## Executive Director's Recommendation

Commission Meeting: July 11, 2019

<b>PROJECT</b> <b>Building Envelope Repairs</b> Hirshhorn Museum and Sculpture Garden 700 Independence Avenue, SW Washington, DC	<b>NCPC FILE NUMBER</b> 7889
	<b>NCPC MAP FILE NUMBER</b> 1.71(38.00)44960
<b>SUBMITTED BY</b> Smithsonian Institution	<b>APPLICANT'S REQUEST</b> Approval of comments on concept plans
<b>REVIEW AUTHORITY</b> Federal Projects in the District per 40 U.S.C. § 8722(b)(1) and (d)	<b>PROPOSED ACTION</b> Approve comments on concept plans
	<b>ACTION ITEM TYPE</b> Consent Calendar

# Hirshhorn Museum and Sculpture Garden Building Envelope Repairs

# Existing and Proposed Panel Section

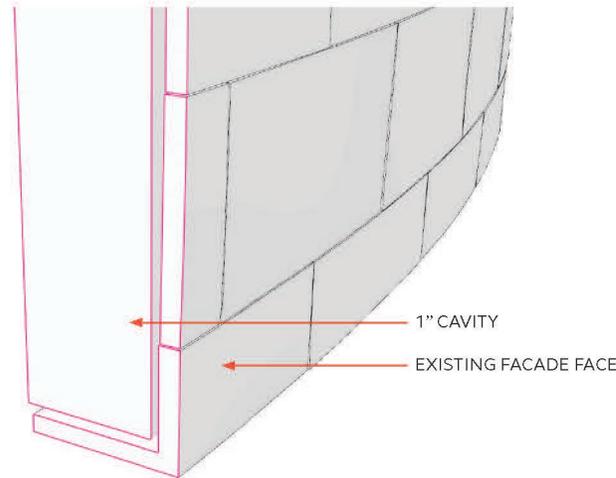
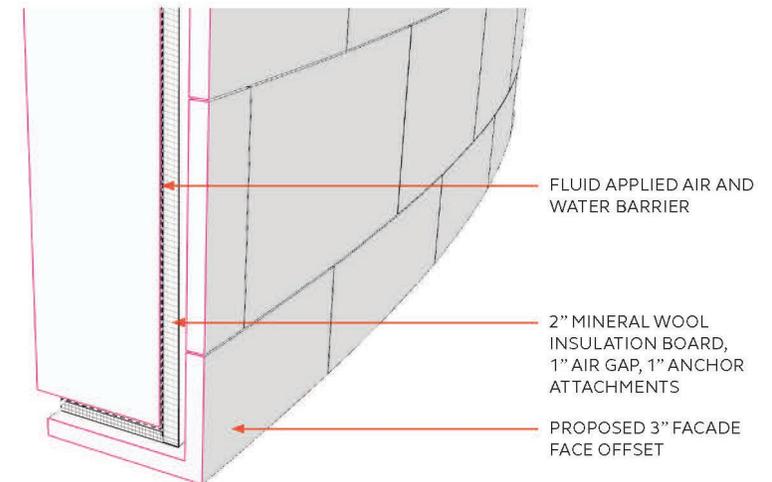
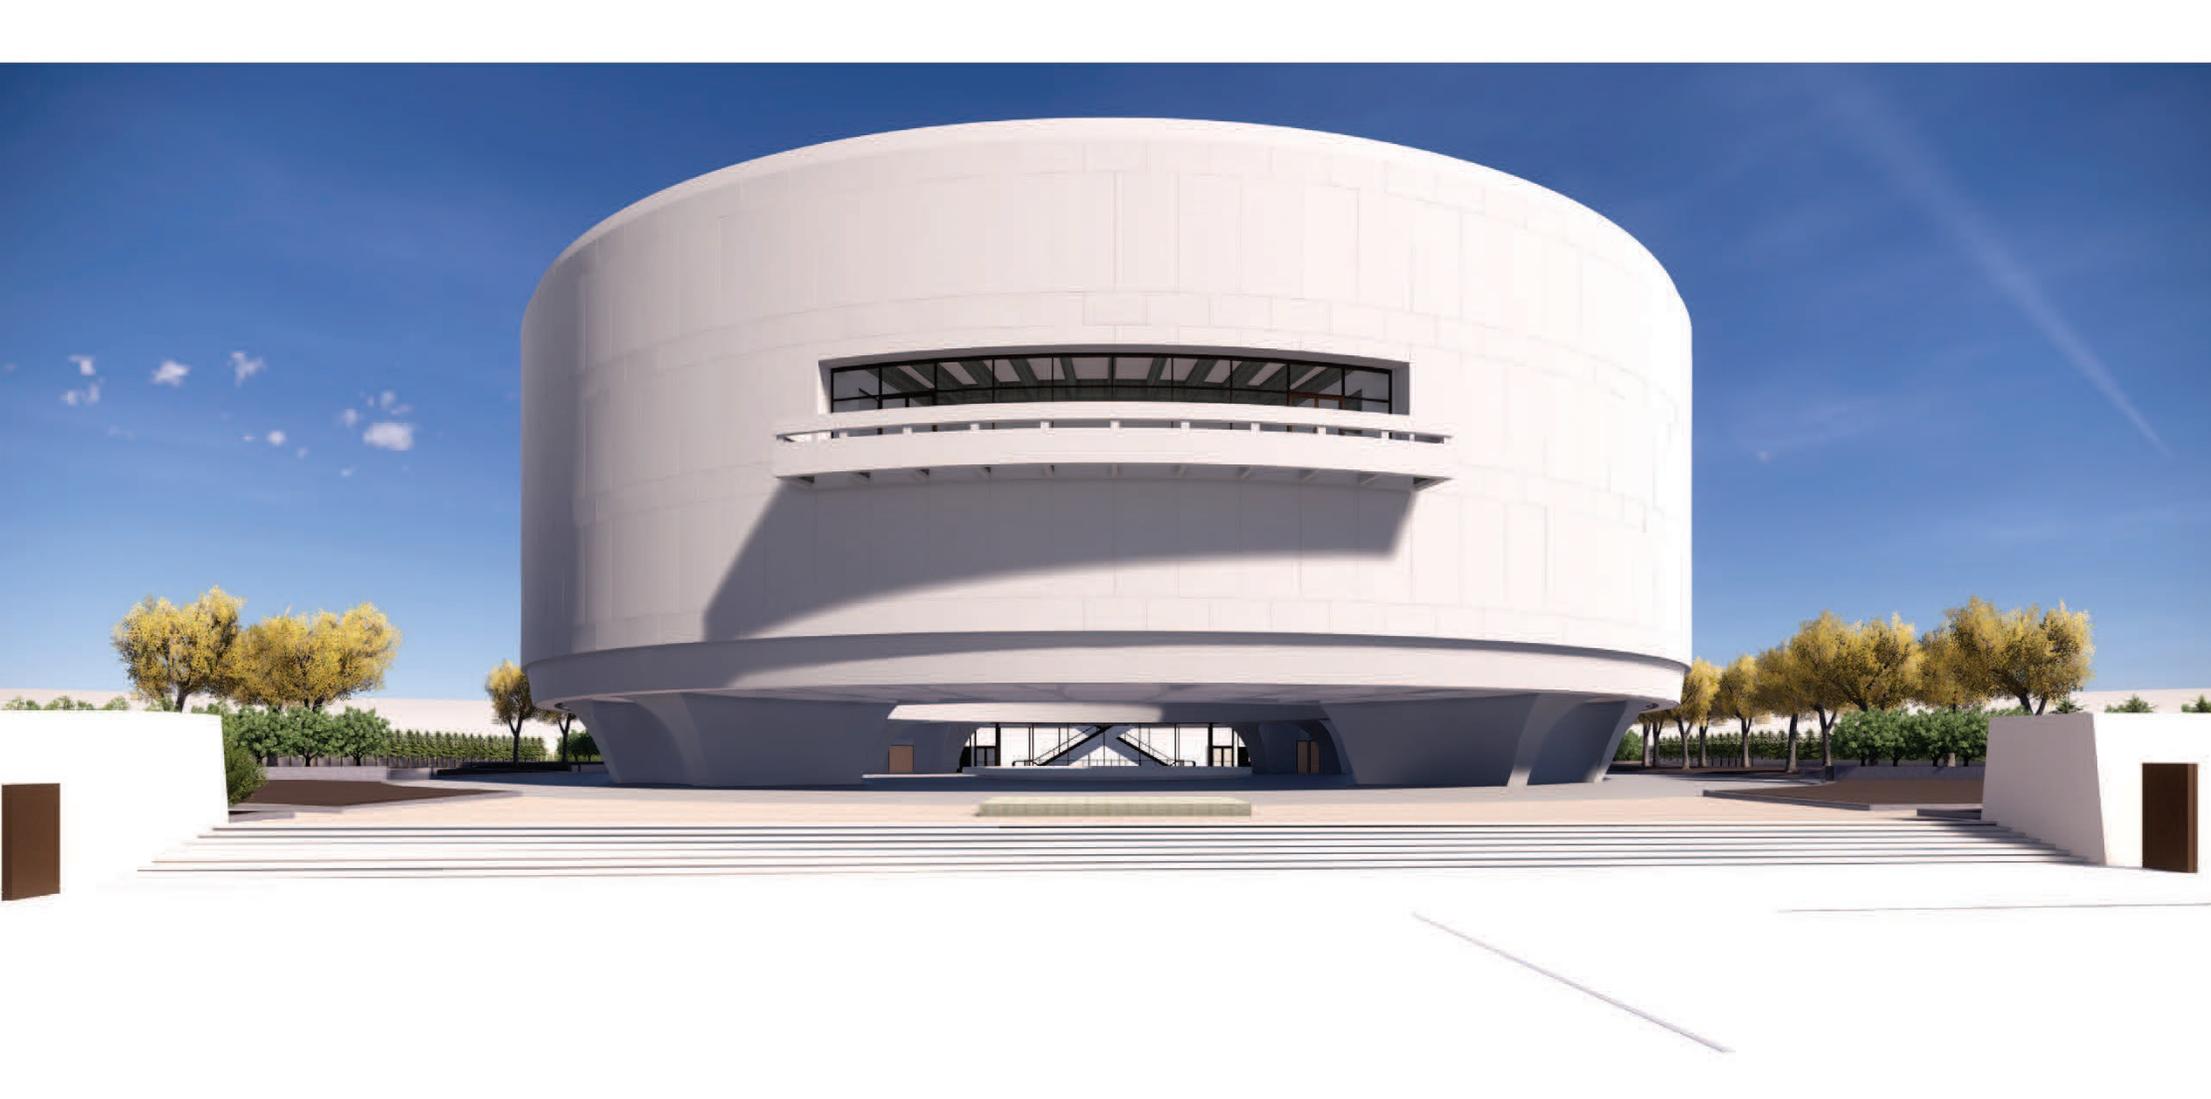
**Finds** the proposed dimensional change in the building section will generally not alter the perception of the building, particularly if the panel joint pattern is retained, and the precast concrete aggregate matches the original design.

Given these findings, the applicant is proposing several repairs to the building envelope. The first, and most significant, includes removing the existing precast panels and replacing them in-kind. An additional three-inch façade offset will also be provided, in addition to the existing one-inch gap. This will accommodate two-inch thick insulation, a one-inch air gap, and a one-inch space for the anchor attachments. The new insulation will help improve energy performance, while the additional gap and an applied water barrier will help prevent infiltration and condensation on the interior of the building. Due to the additional spacing, the entire drum of the building will essentially grow three inches outward on all sides. Based upon the submitted renderings, staff does not find that this dimensional change is particularly significant or perceptible. The applicant proposes to retain the same joint pattern and to match the concrete aggregate in the precast panels. Therefore, staff recommends the **Commission finds the proposed dimensional change in the building section will generally not alter the perception of the building, particularly if the panel joint pattern is retained, and the precast concrete aggregate matches the original design.**
